Town of Milford Meeting Notice

Board or Commission: Conservation Commission

Date and Time of Meeting: Wednesday December 16, 2020 at 7.00 P. M

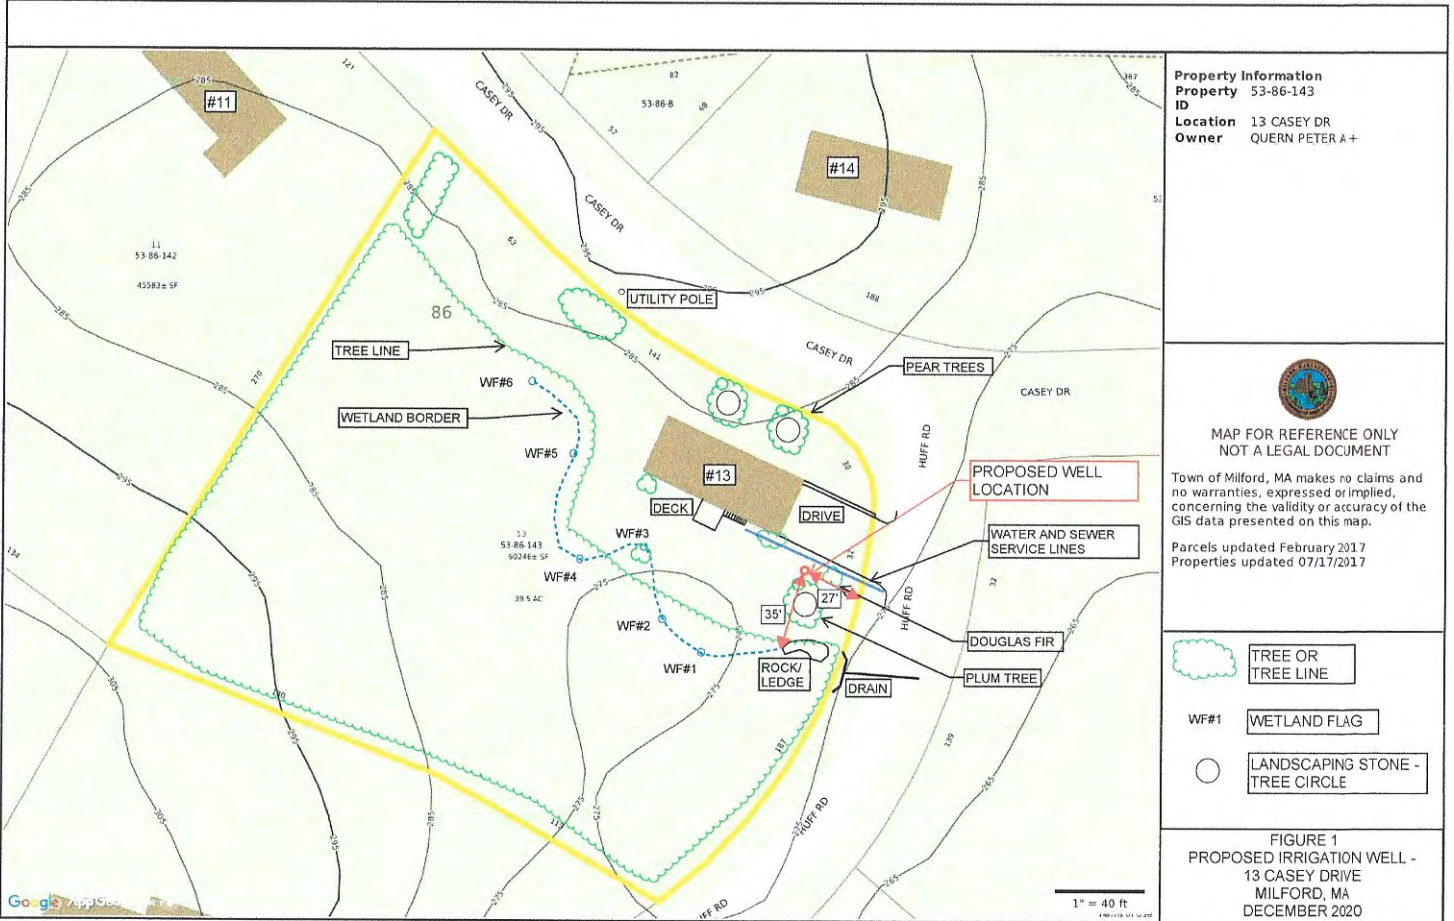
I have reviewed the Determination of Applicability for the installation of an Irrigation Well in the back yard of an existing residential house.

I recommend the issuance of a **Negative** Determination of Applicability.

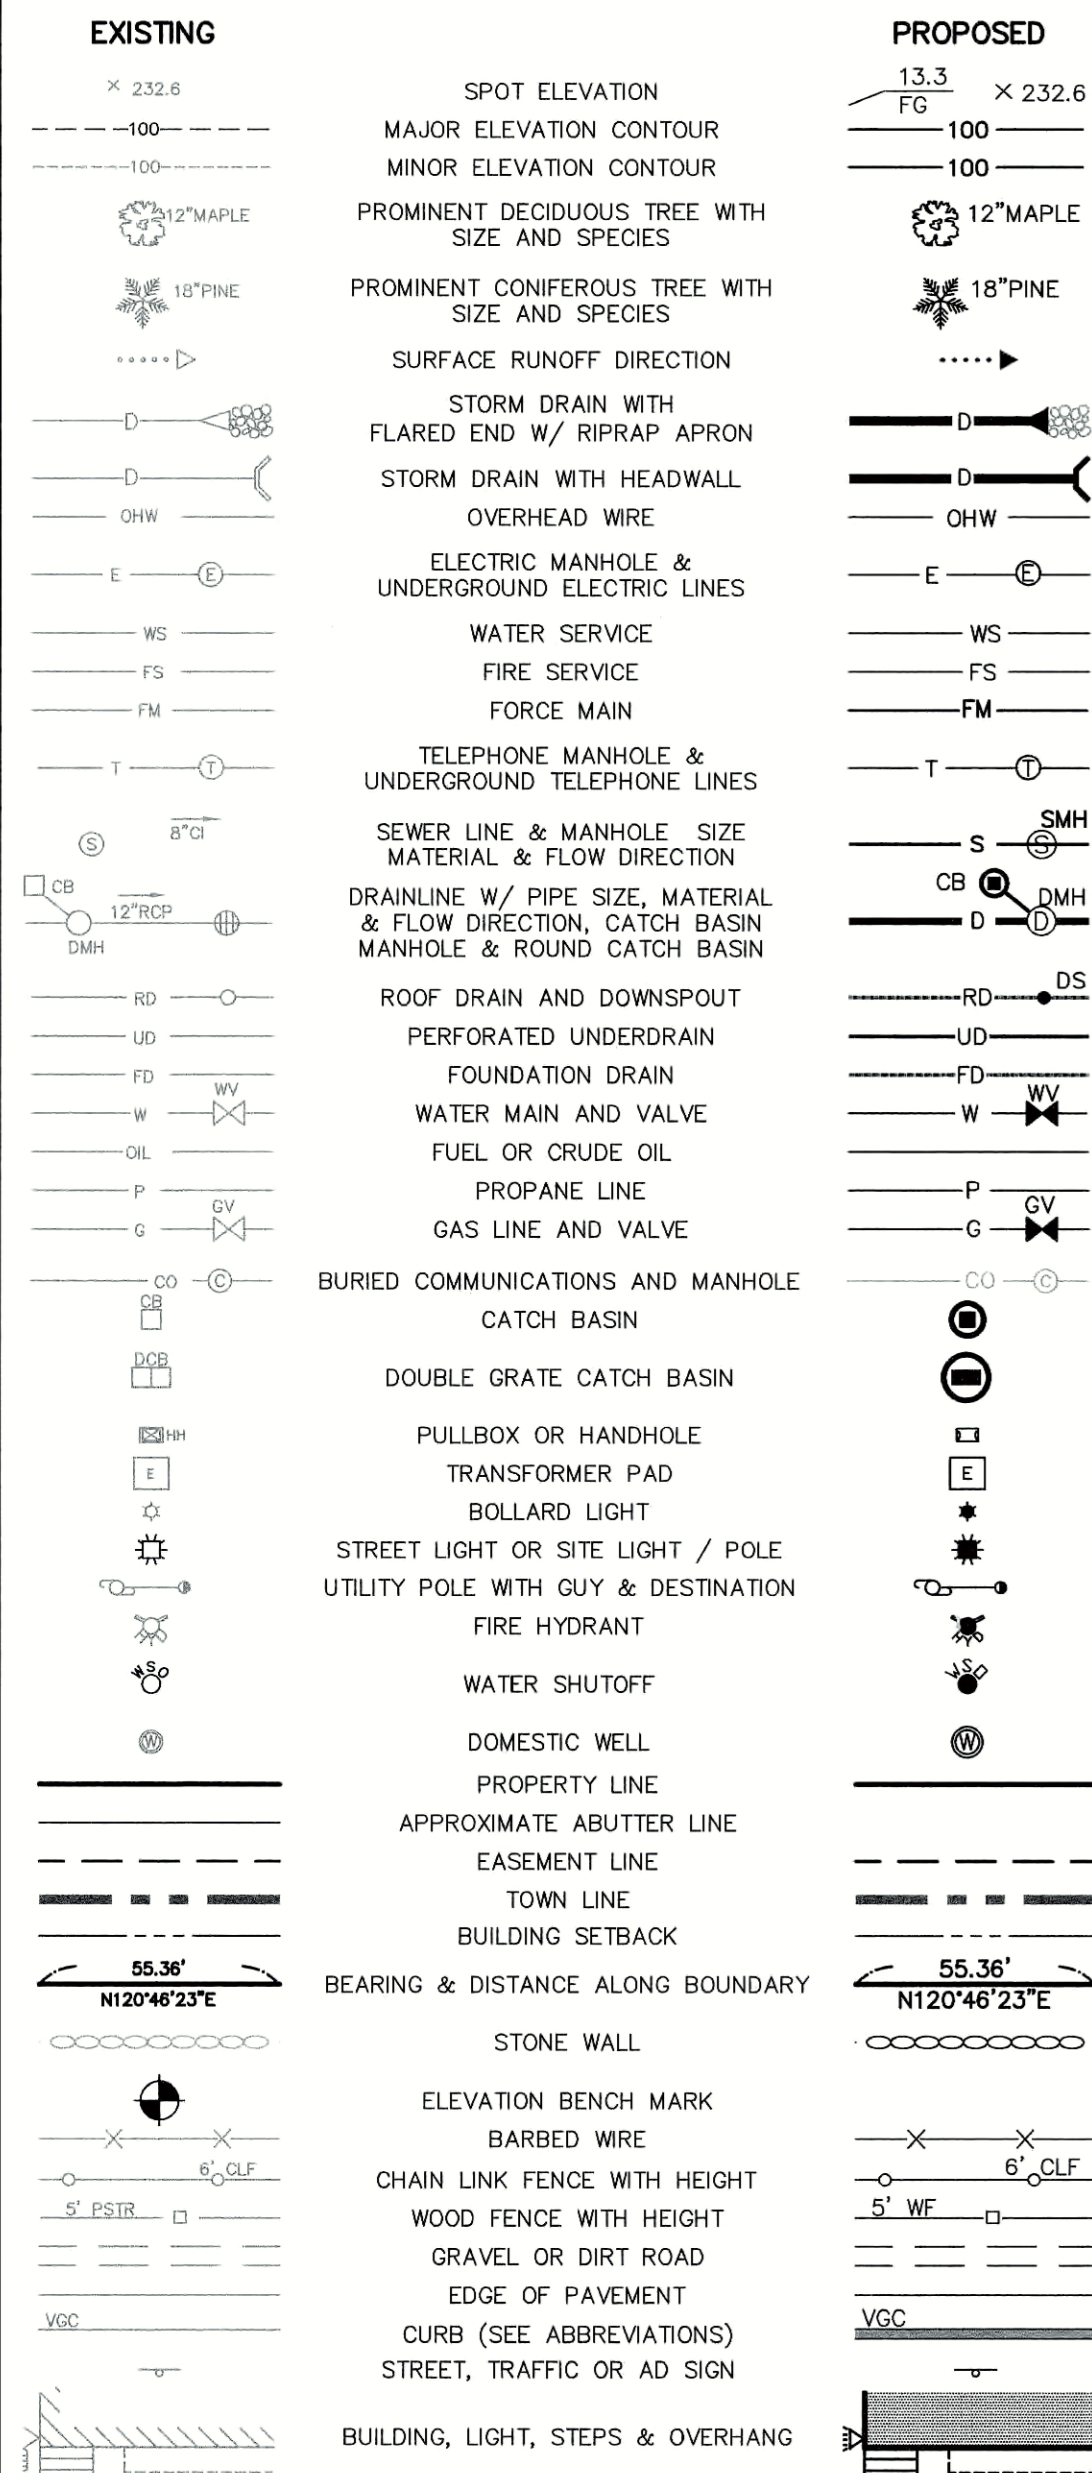
This Lot was recently approved by the Commission this past October of 2020. The amendment shifts the proposed building to the south by approximately 17-feet.

Following a review of the site plan it appears there is no foundation drain shown, the Commission typically requires that the drains be shown.

I recommend approval of the project and the issuance of an **Amended** Order of Conditions.

Property Information
Property ID 52-293-2
Location 7 ARIANA CIR
Owner LILY BEAN LLC &

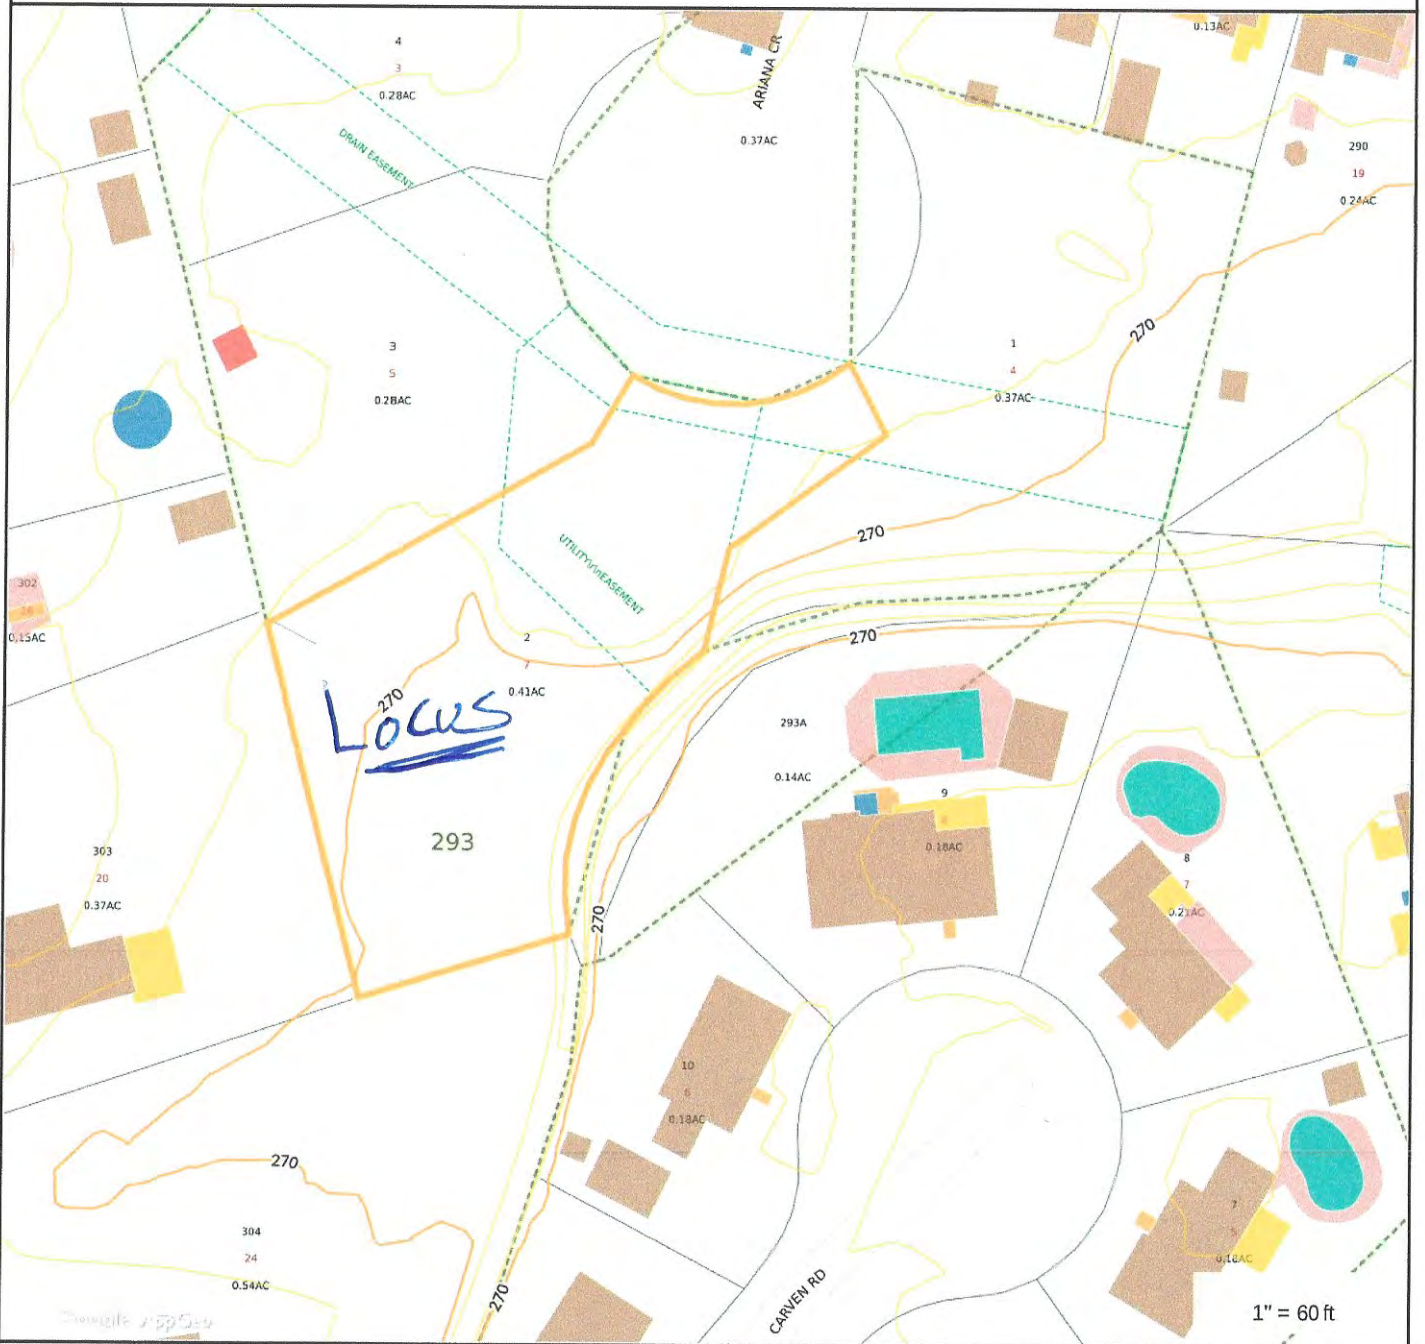
I have reviewed the files and found a filing for a pool installation at 7 Carven Road, the plans have no topography or spot elevations, as this filing was simply to convert a lawn area into an inground pool area. The Town's GIS shows the abutting land at an approximate elevation of 270, see the attached Exhibit.
